This letter is in regard to the proposed technical specification change request for the installation of undervoltage relay bypass pushbuttons at the Davis-Besse Nuclear Power Station Unit 1. The original request was submitted as Attachment III to Toledo Edison, letter dated March 23, 1979 (Serial No. 487).

DRAWING CHANGE NOTICE Q

JOB NO.	DRAWING NO.	REV. NO.
7749	E-34B SH 14A	1
DCN NUMBER	PAGE	OF
E-34B-10	1	2

Block Diagram
Scheme AC103 (AD103)
Channel 1(2)

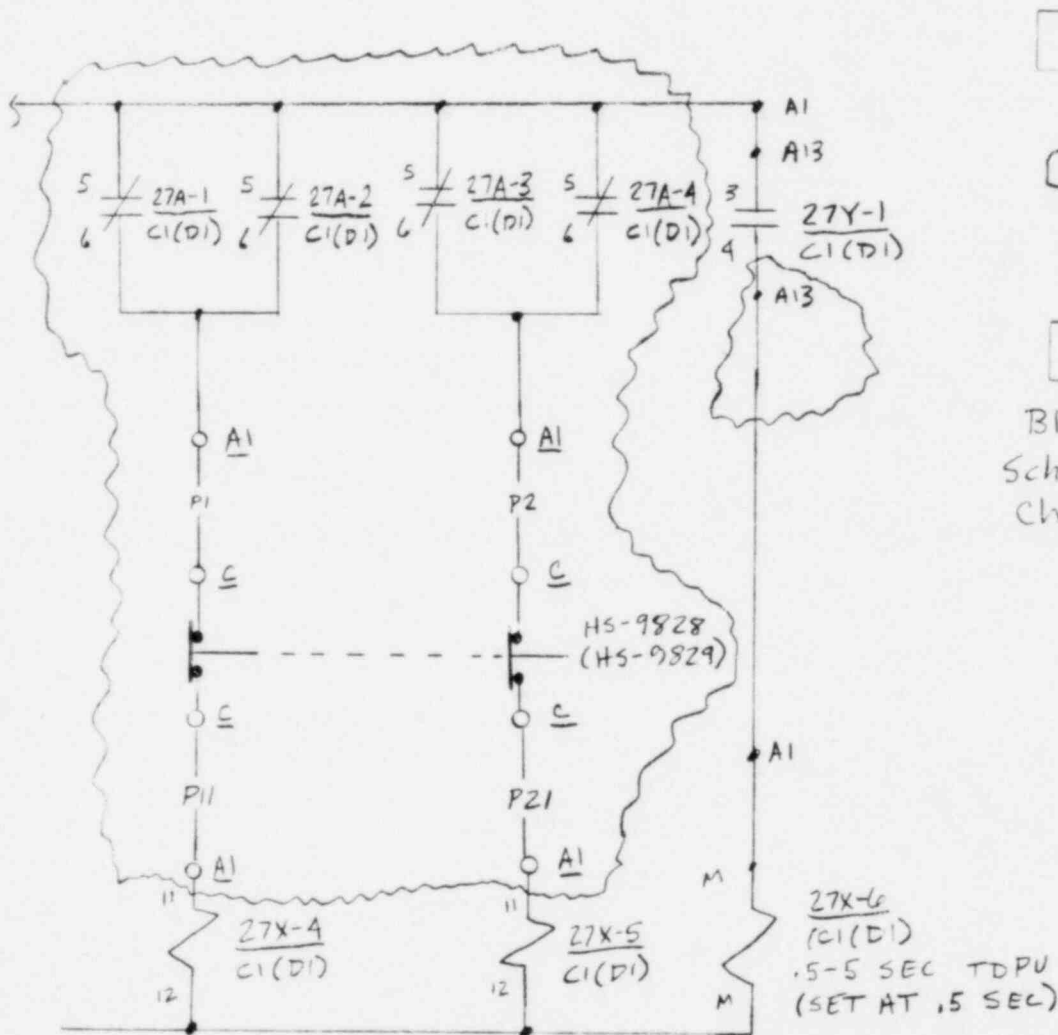
The Drawing Change Notice (DCN) attached reflects the modified undervoltage sensing scheme for degraded electrical power sources. This does not affect the loss power sensing function in any way (relays performing this function are set at 59%).

The 90% undervoltage relay contacts (27A1, 2, 3 and 4) are normally open. Upon sensing a degraded voltage condition, auxiliary relay contacts 27A1, 2, 3 and 4 are closed, thus energizing relay coils 27X-4 and 5. In turn this will lead to starting of the emergency diesel generators and transfer the essential buses to these diesel generators.

As indicated by the DCN, the pushbuttons when depressed simply prevent circuit completion such that relay coils 27X-4 and 5 would see no change of condition during the voltage drop associated with pump starting. When the pushbuttons are released, the circuit is mechanically restored to its original condition. The pushbuttons themselves do not activate or deactivate any circuitry.
